E-3 AWACS
CORROSION PREVENTION ADVISORY BOARD
(CPAB)

12 JULY 1990
TINKER AFB, OK

E-3 CORROSION PREVENTION ADVISORY BOARD MINUTES
12 JULY 1990

SEE NOTE ON PARTS LIST PAGES
FIGURE 17. FAIRING INSTL. STA 990 TO 1060 WING TO BODY (SHEET 3)

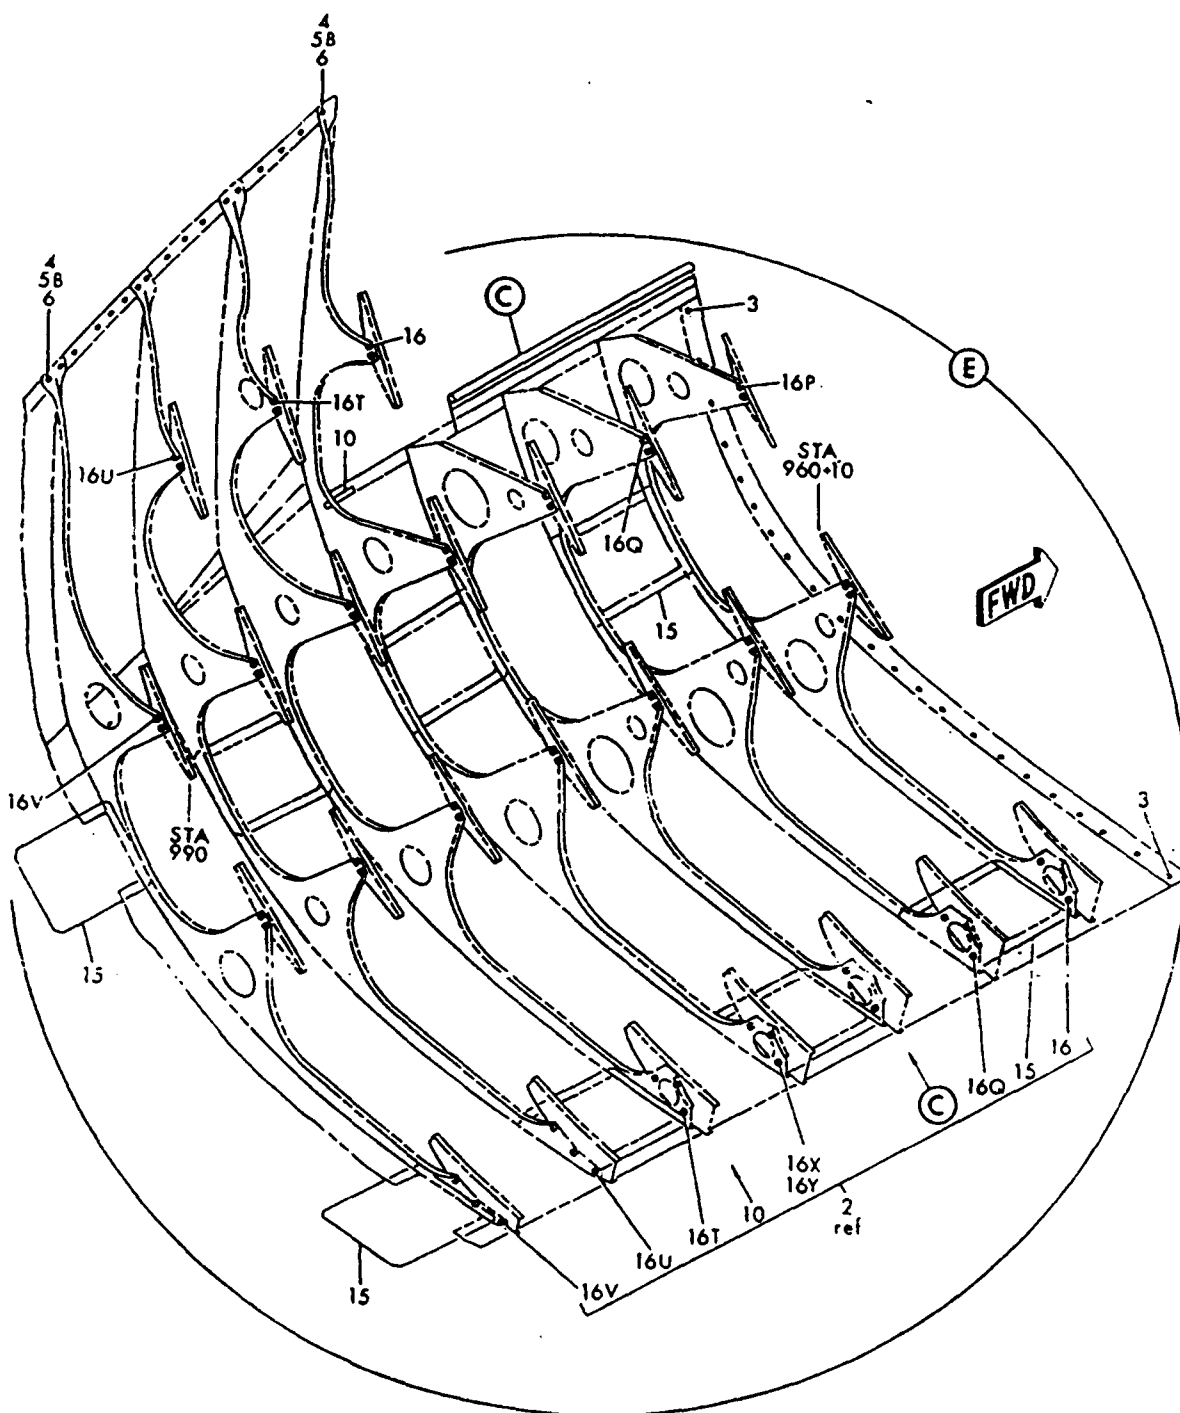
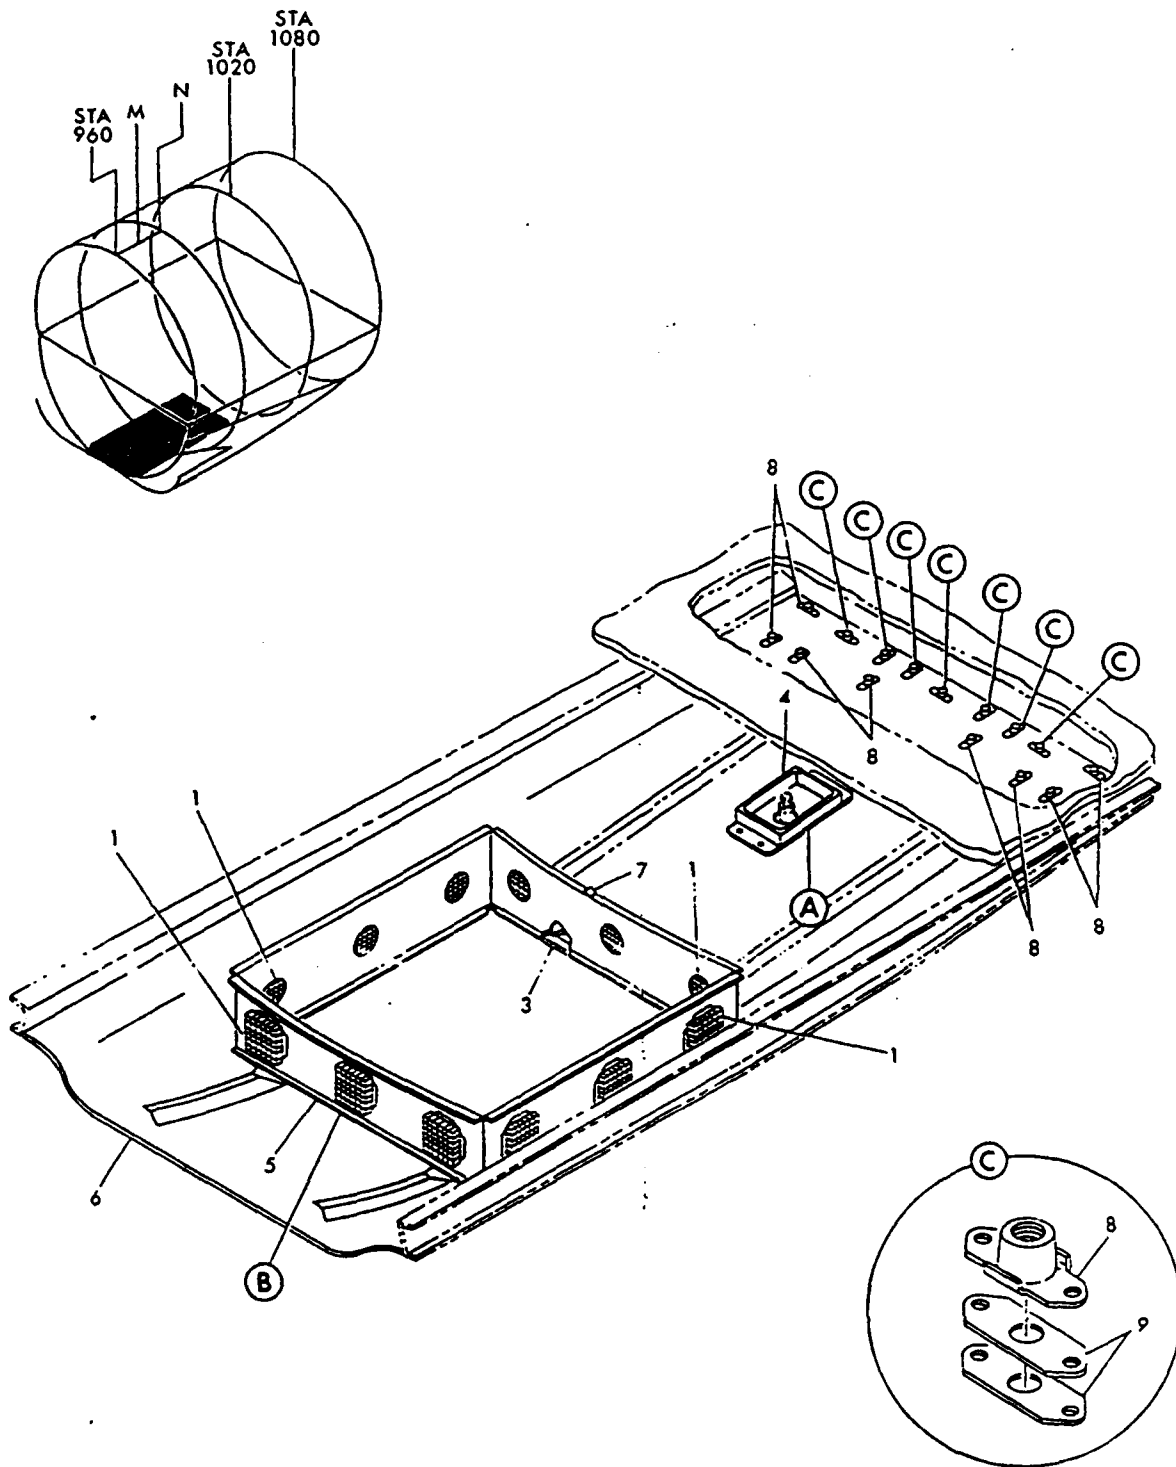
E-3		CORROSION PREVENTION ADVISORY BOARD		ACTION ITEM #: 89-12	
O R I G I N A L	SUBJECT: Fairing Installation STA 960 to 1020, Wing to Body		BACKGROUND DATA:		
			PART NUMBER: 65-22871-31		
			NSN: DRAWING(S):		
	NAME: HFw Franz-Josef Deckers ORGANIZATION: NAEWF E-3 Comp. TELEPHONE: 01-49-2451-63-6215 DATE SUBMITTED: 16 NOV 1989		TO(S): 1E-3A-4-53-1 FIGURE: 53-02-7A INDEX: 48 WORK UNIT CODE:		
O R	PROBLEM: Water is collecting in the wing to body fairing. Existing drain holes in the lower frame are too high, resulting in water level being 1/2" high before draining.				
	RECOMMENDED ACTION: Install drain holes in the lowest spot of both wing to body fairings.				
	(USE CONTINUATION SHEET IF NECESSARY)				
C P A B A C T I O N	STATUS:				
	16 Nov 1989: OC-ALC/MMKRA will investigate problem, prepare ECO, and coordinate TCTO with OC-ALC/MMKRTA to install drain hole(s) to correct problem.				
	OC-ALC/MMKRA will also investigate related water collection problem with the doppler velocity sensor cavity aft of the MLG wheel wells.

12 March 1990: ECO's documenting additional drain holes have been submitted by MMKRA. OC-ALC/MMKRTA is preparing a TCTO to install the drain holes. Once installed, drainage should be sufficient to correct water retention problems in the fairings and the doppler velocity sensor cavity.				
	July 1990: TCTO is being written by MMKRTA and will be finished by next CPAB. 552 AWACW/MAQ is setting up kitproofing.				
ACTION OPR(S): OC-ALC/MMKRA		POINT(S) OF CONTACT: LT. Jim Kihle		EST. COMPLETION DATE:	
STATUS: OPEN DATE CLOSED: FINAL DISPOSITION:

Figure 6-9. Outboard Wing Assembly

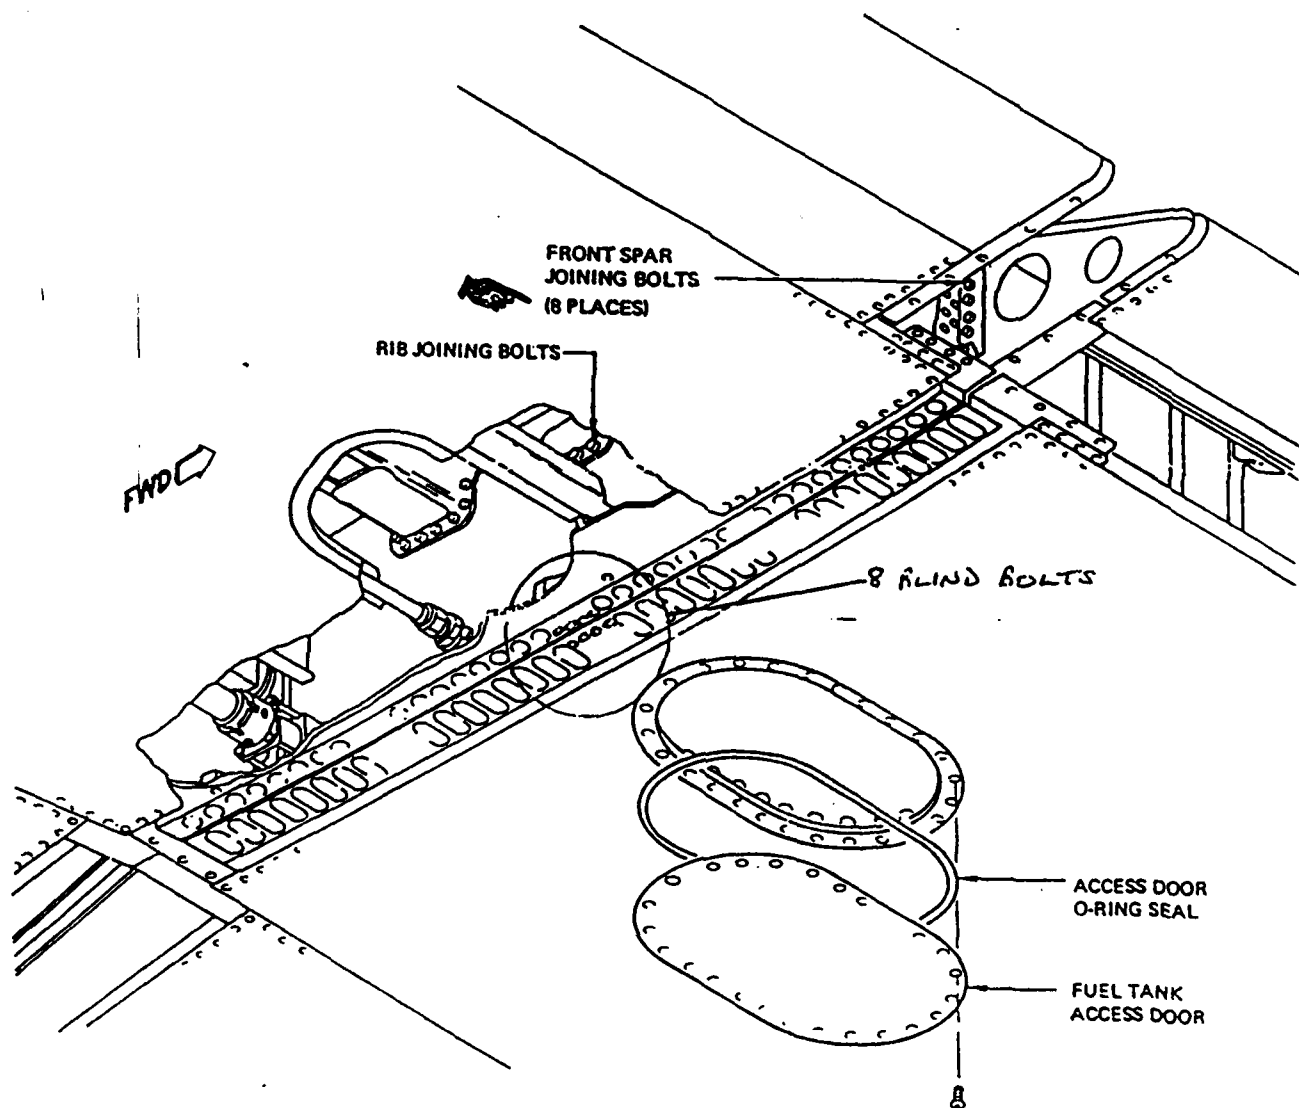
MMKRA will included inspection of the lower surface in T.O. -6 and FY91 ACI. MMKRA will take action to investigate the addition of of drain holes.
